PCN Number:	20100910003			PCN Date:	
Title:	MSP430F54xxA and MSP430F55xx Device Derivatives: Flash Read Error Susceptibility				
Customer Contact:	PCN Manager	Phone:	+1(214) 480-6037	Dept:	Quality Services
Proposed 1st Ship Date:		Estimated Sample Availability:			
Change Type:					
<input type="checkbox"/>	Assembly Site	<input type="checkbox"/>	Assembly Process	<input type="checkbox"/>	Assembly Materials
<input checked="" type="checkbox"/>	Design	<input type="checkbox"/>	Electrical Specification	<input type="checkbox"/>	Mechanical Specification
<input type="checkbox"/>	Test Site	<input type="checkbox"/>	Packing/Shipping/Labeling	<input type="checkbox"/>	Test Process
<input type="checkbox"/>	Wafer Bump Site	<input type="checkbox"/>	Wafer Bump Material	<input type="checkbox"/>	Wafer Bump Process
<input type="checkbox"/>	Wafer Fab Site	<input type="checkbox"/>	Wafer Fab Materials	<input type="checkbox"/>	Wafer Fab Process

MSP430F54xxA Device Derivatives Technical Assessment: Flash Read Error & Susceptibility

MSP430F55xx Device Derivatives Technical Assessment: Flash Read Error & Susceptibility

Figure 2. Error illustration for MSB of double word #4

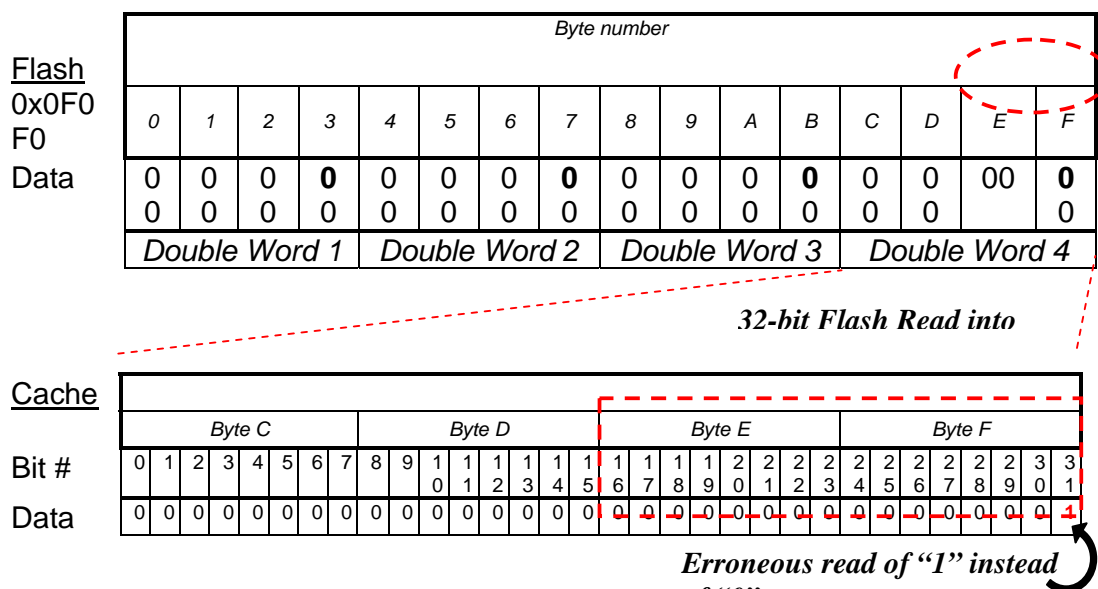
The flash read error only affects the read access of the most significant bit (MSB) of each 32-bit Flash access by the cache. No other bit locations are affected. Each 31st bit location - i.e. the MSB of the 4th byte for each double word access, is susceptible to being read as “1” when it should be “0”. Bit locations for an entire 32-bit double word are defined as 0 to 31.

Furthermore, the issue only affects the 32-bit MSB when the flash bit is programmed as a “0”. In cases where the actual value stored is logic “1”, the bit will always read valid as logic “1” and is not susceptible to an invalid read.

Example: This illustration considers 16 bytes of flash data starting at address 0x0F0F0 and all contain the value 0x00. A CPU instruction execution triggers an access of the Flash word (at 0x0F0FE) and saves it to CPU register R5:

Instruction: `mov.w &0x0F0FEh, R5`

Result: Valid: R5= 0000h
Invalid: R5= 8000h

The read operation by the CPU of address 0x0F0FE will actually trigger the reading of double word #4 from flash (data from 0x0F0FC to 0x0F0FF), which is then stored into the 32-bit cache. The uppermost two bytes (0x0F0FE and 0x0F0FF) make up the 16-bit word located at 0x0F0FE. The result of the read in the case of a flash read error is an invalid readout of the MSB for the given double word access. Instead of the expected logic "0", a logic "1" may be erroneously read out and stored in the cache for CPU computation: 0x8000 is erroneously read out and moved to R5 instead of 0x0000. This potential error applies to the MSB for each double word as indicated by the bold "0"s in Figure 2 at each 4th byte.

Figure 3. JMP\$ alignment and read error behavior

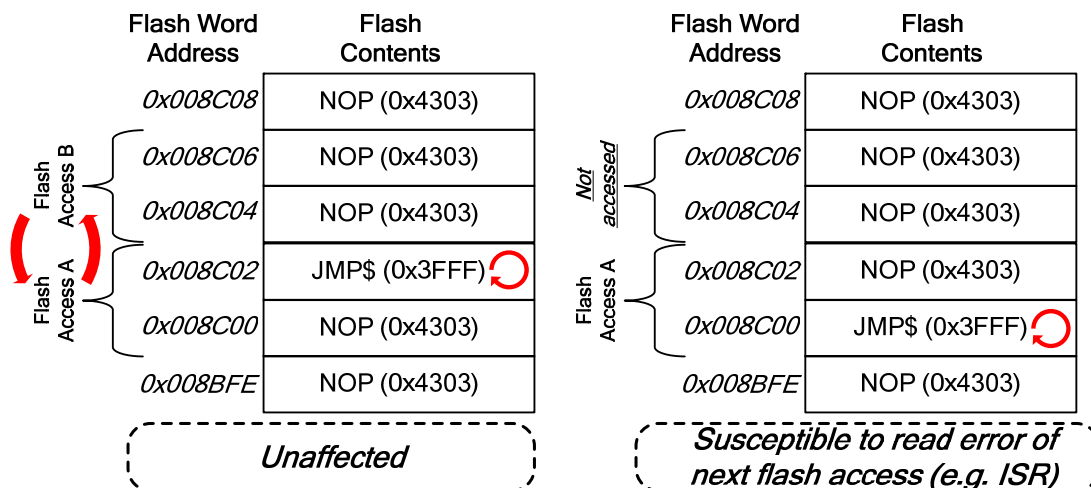
Such operation may be affected by the flash read error depending on memory position of the `JMP$` instruction. The read error is possible when the `JMP$` instruction resides in the lower word of a double word fetch from flash allowing execution to happen completely from cache turning off flash access. In this case, when the execution of the `JMP$` exceeds the IDLE time discussed in section 3.4 prior to servicing an interrupt, the device is susceptible to the flash read error with the next ISR service and the same scenarios outline in section 4.1 may apply.

Figure 3 shows the relationship of the `JMP$` instruction position in memory and the behavior of the Flash access. On the right, the `JMP$` is at the lower word of the double word fetched from flash. This placement results in the CPU being able to execute entirely from the cached double word containing the `JMP$` instruction which stops flash access activity. Execution of the `JMP$` in such a memory alignment for a time exceeding the IDLE time discussed in section 3.4 can result in a read error on the next flash access – e.g. servicing an active ISR.

However, when the `JMP$` instruction resides in the upper word of the double word memory fetch, as shown in the left portion of Figure 3, the cache continuously alternates between flash accesses A and B which keeps the flash access constant and unaffected by the read error on a subsequent ISR service fetch.

Figure 4. Core voltage settings with reduced susceptibility

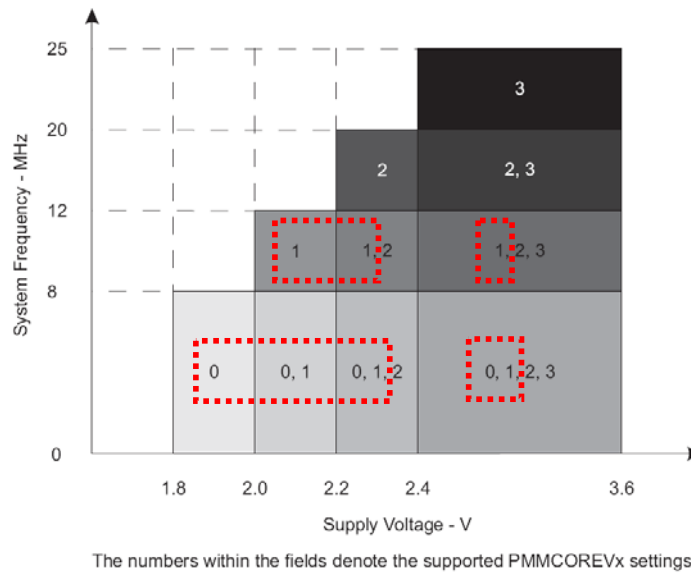
The Vcore settings 0 and 1 and corresponding operating ranges are highlighted in the figure. These Vcore level settings result in reduced susceptibility to the flash read issue vs levels 2 and 3.

While all Vcore settings when used under the proper Vcc and clock frequency ranges are valid for device operation, usage of Vcore level 2 and 3 settings are twice as likely to result in flash read errors at susceptible bit locations compared to levels 0 and 1.

Operating the device at an internal core voltage level 0 or 1 can reduce the likelihood of flash read error occurrence by as much as 50% versus operation at level 2 and level 3.

Figure 6. Error illustration for MSB-1 of double word #4

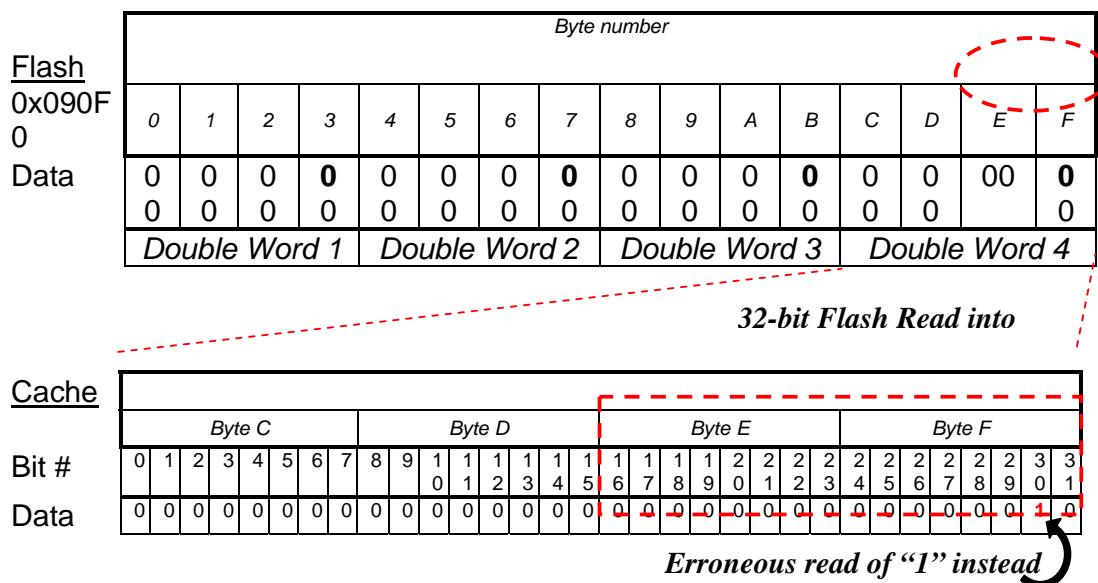
The flash read error only affects the read access of the next-to-last most significant bit (MSB-1) of each 32-bit Flash access by the cache. No other bit locations are affected. Each 30th bit location - i.e. the MSB-1 of the 4th byte for each double word access, is susceptible to being read as “1” when it should be “0”. Bit locations for an entire 32-bit double word are defined as 0 to 31.

Furthermore, the issue only affects the 32-bit MSB-1 when the flash bit is programmed as a “0”. In cases where the actual value stored is logic “1”, the bit will always read valid as logic “1” and is not susceptible to an invalid read.

Example: This illustration considers 16 bytes of flash data starting at address 0x090F0 and all contain the value 0x00. A CPU instruction execution triggers an access of the Flash word (at 0x090FE) and saves it to CPU register R5:

Instruction: `mov.w &0x090FEh, R5`

Result: Valid: R5= 0000h
Invalid: R5= 4000h

The read operation by the CPU of address 0x090FE will actually trigger the reading of double word #4 from flash (data from 0x090FC to 0x090FF), which is then stored into the 32-bit cache. The uppermost two bytes (0x090FE and 0x090FF) make up the 16-bit word located at 0x090FE. The result of the read in the case of a flash read error is an invalid readout of the MSB-1 for the given double word access. Instead of the expected logic "0", a logic "1" may be erroneously read out and stored in the cache for CPU computation: 0x4000 is erroneously read out and moved to R5 instead of 0x0000. This potential error applies to the MSB-1 for each double word as indicated by the bold "0"s in Figure 2 at each 4th byte.

Figure 7. JMP\$ alignment and read error behavior

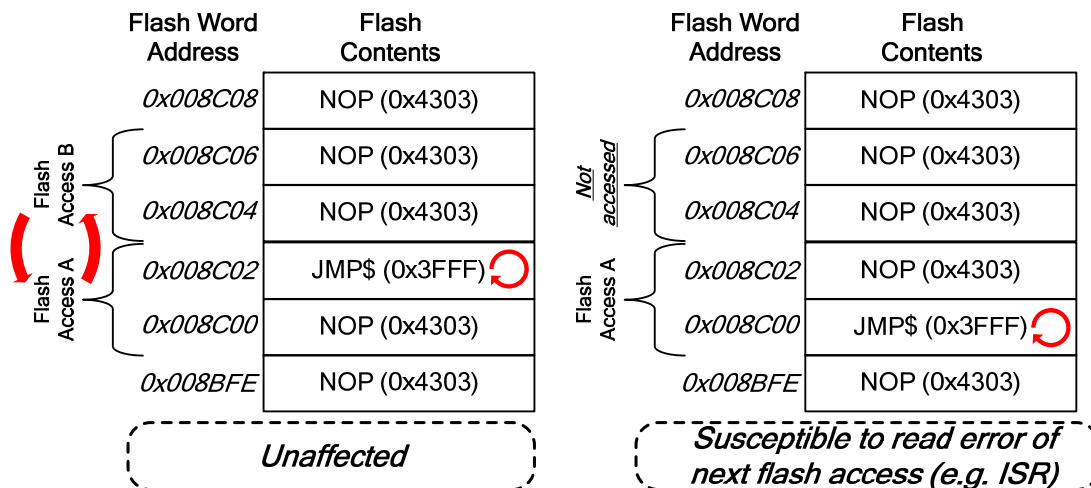
Figure 3 shows the relationship of the JMP\$ instruction position in memory and the behavior of the Flash access. On the right, the JMP\$ is at the lower word of the double word fetched from flash. This placement results in the CPU being able to execute entirely from the cached double word containing the JMP\$ instruction which stops flash access activity.

When the JMP\$ instruction resides in the upper word of the double word memory fetch, as shown in the left portion of Figure 3, the cache continuously alternates between flash accesses A and B which keeps the flash access constant.

It is assumed that when using a while(1) program flow, interrupts are active. Given that the interrupt vector address locations are in bank 1 and unaffected, servicing of the ISR and subsequent code execution by the CPU will not be affected by the flash read error. This results in usage of while(1) being unaffected by the flash read error.

Figure 8. Core voltage settings with reduced susceptibility

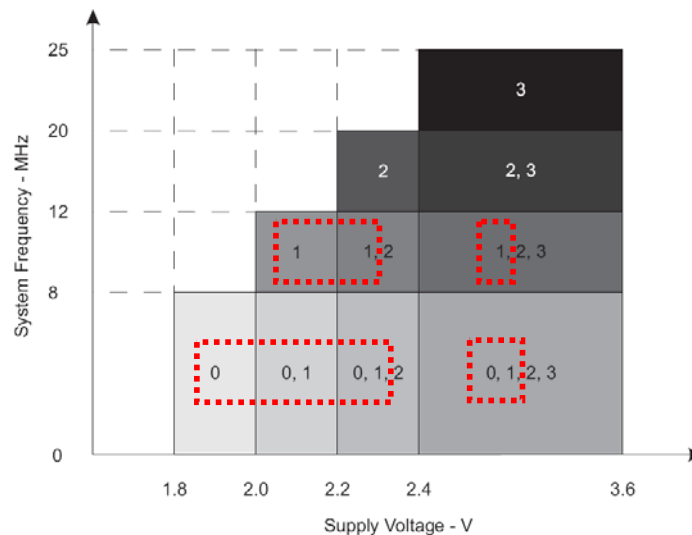
The Vcore settings 0 and 1 and corresponding operating ranges are highlighted in the figure. These Vcore level settings result in reduced susceptibility to the flash read issue vs levels 2 and 3.

While all Vcore settings when used under the proper Vcc and clock frequency ranges are valid for device operation, usage of Vcore level 2 and 3 settings are twice as likely to result in flash read errors at susceptible bit locations compared to levels 0 and 1.

Operating the device at an internal core voltage level 0 or 1 can reduce the possibility of flash read error occurrence by as much as 50% versus operation at level 2 and level 3.
